Access Compliance Report Public Rights-of-Way (Curb Ramps)

Main Street: FLAMINIAN_WAY Cross Street: PINCIAN_WAY Location: SW

ADA ID: RPRK211012180553 Ramp Type: Type 4 - Parallel Initial Pass/Fail: Fail Overall Compliance: No Severity Score: 15

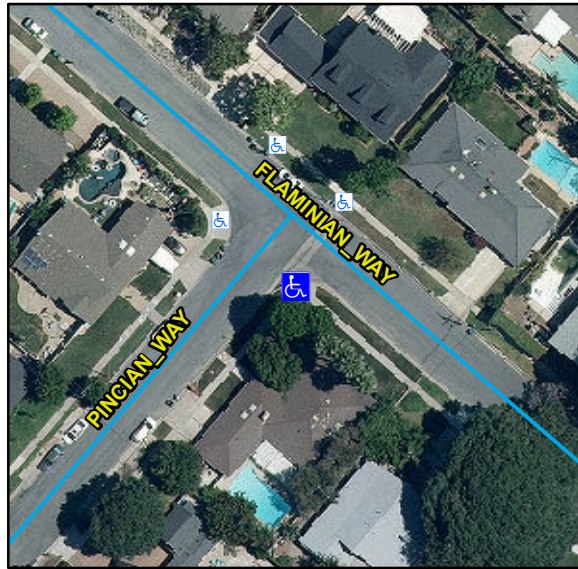
R304.2.2, R204.3, R304.5.3, STD 1115

Remove & Replace Curb Ramp With Two New Directional Ramps or Equivalent.
